**SUNDRY NOTICES AND REPORTS ON WELLS**  
***Do not use this form for proposals to drill or to re-enter an abandoned well. Use Form 3160-3 (APD) for such proposals.***

HILCORP ENERGY COMPANY  
San Juan 32-7 Unit 69  
Frac Isolation  
API: 3004524777

**San Juan 32-7 Unit 69 - PROPOSED WELLBORE SCHEMATIC**

Operator: HILCORP ENERGY COMPANY 1111 Travis Street Houston, TX 77002	OGRID: 372171
	Action Number: 367850
	Action Type: [C-103] NOI Workover (C-103G)

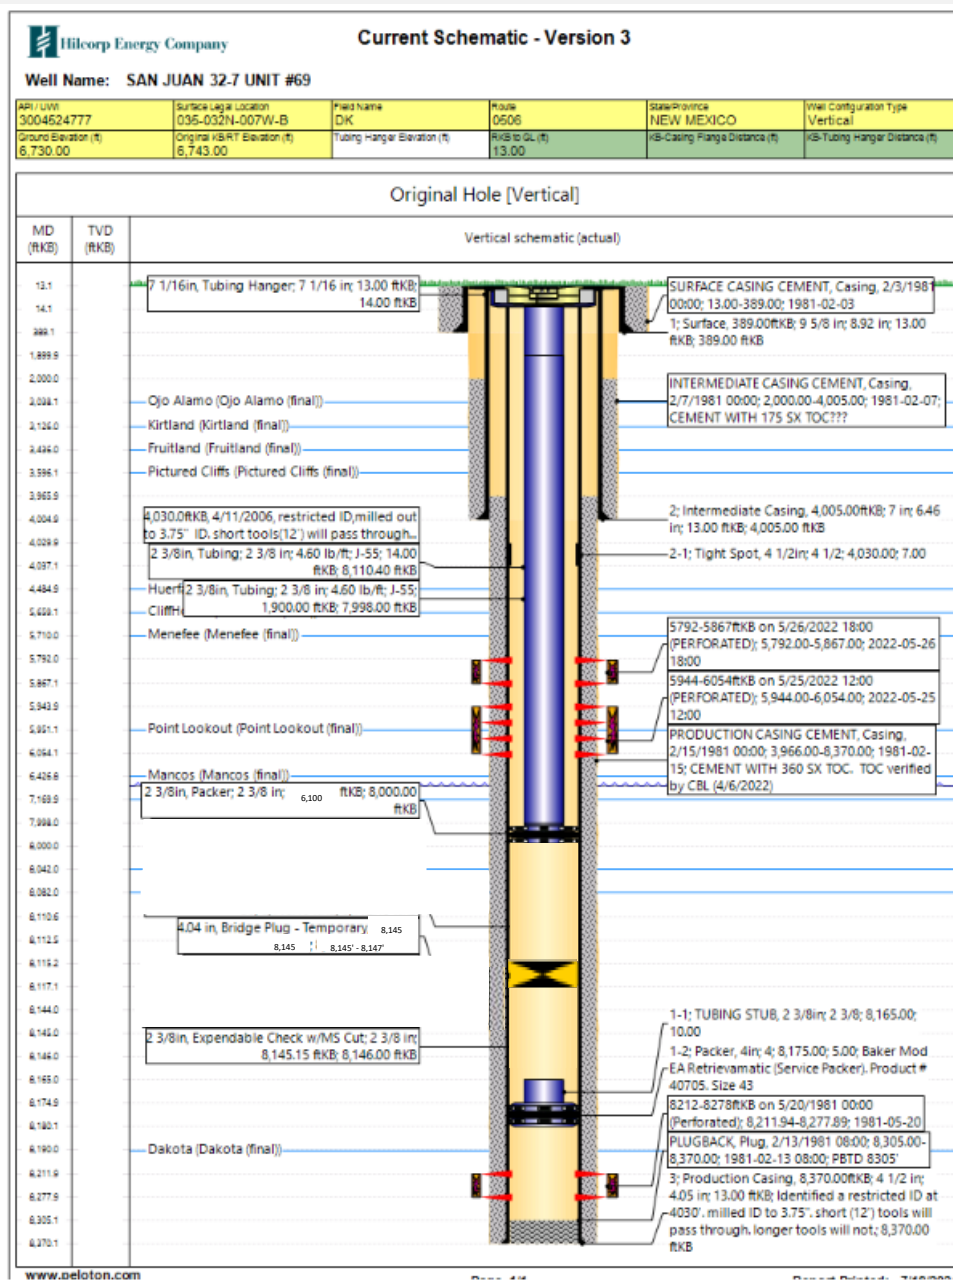
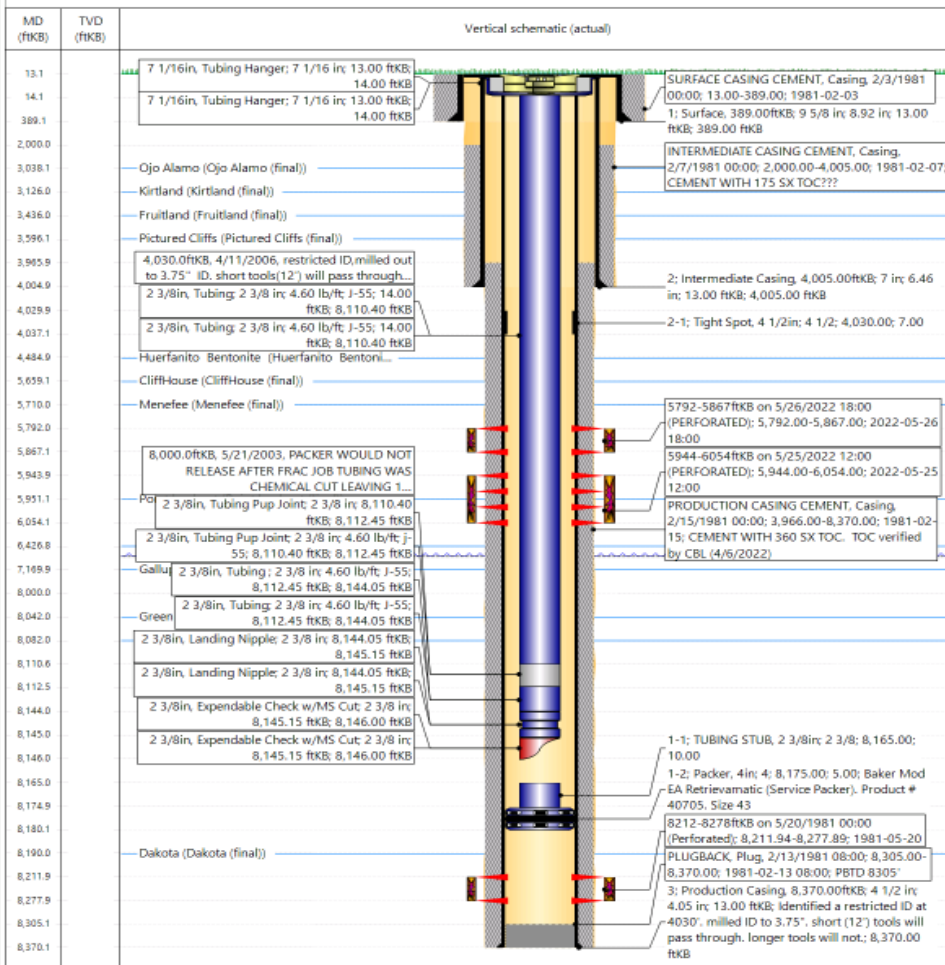
4.	Set CIBP 50' above top of Dakota perforations +/-8,162'. Set packer 50' below Mesa Verde perforations at +/-6,100', load hole with 2% KCl, pressure test down tubing to ensure plug set. If unable to set packer below MV, set packer 50' above MV perfs at +/-5,740.

5.	Leave well isolated for 9-12 months.	
6.	MIRU after isolation period. POOH packer and tubing, mill out CIBP above the Dakota, and clean out wellbore.

Created By	Condition	Condition Date
mkuehling	Production equipment needs to be removed - cibp and packer required to be removed prior to end of 12 month period. Report on subsequent.	7/30/2024
